Service Bulletin	SB AD32/08 Revision: 1.1
---	---------------------------	---

TITLE:	Hardware Modification for AD32.EK Air Data Display (Antivibration measure)
DOCUMENT NUMBER:	SB AD32/08
EQUIPMENT:	AD32 Air Data Display
© Copyright by THOMMEN AIRCRAFT EQUIPMENT AG, CH-4132 MuttENZ, Switzerland

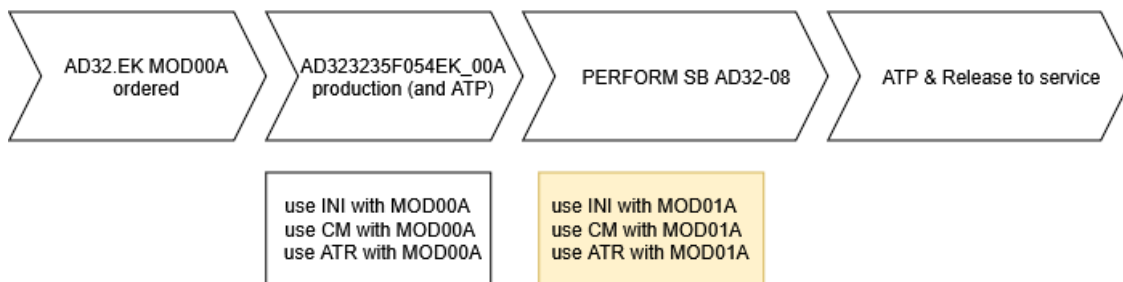
STEP	PICTURE	PROCEDURE
1		NOTE: The AD32, HW 4.10, can be either with or without an ALT light. The AD32, HW 4.10, can be either with or without an alerter-set knob. This procedure is the same for all variants. Remove the grub screw from the baro-push-reset knob, then remove the knob from the axle. If installed, remove the grub screw from the alerter-set knob, then remove the knob from the axle. Clean the two knobs and grub screws.

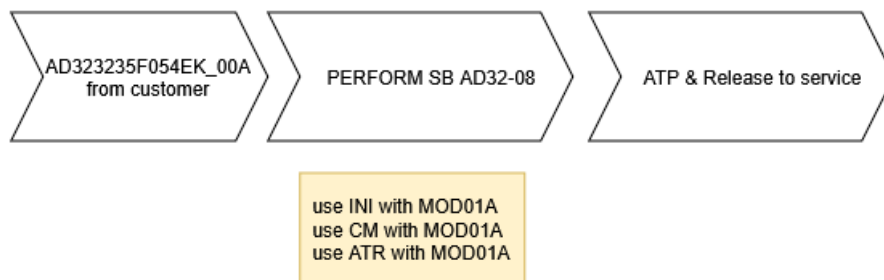
STEP	PICTURE	PROCEDURE
5		Prepare the siliconization of the PCB connectors on the Power board. This treatment is done only for the two connectors on Power board. Apply SILICONE ADHESIVE on the angled 20 pin and the 15 pin PCB connector. <i>This procedure and step 6 must be carried out if SILICONE ADHESIVE has not already been applied to the PCB connectors.</i>
6		Only cover the pins with the SILICONE ADHESIVE . No SILICONE ADHESIVE should get between two PCBs. The power board must still be removable after this treatment.
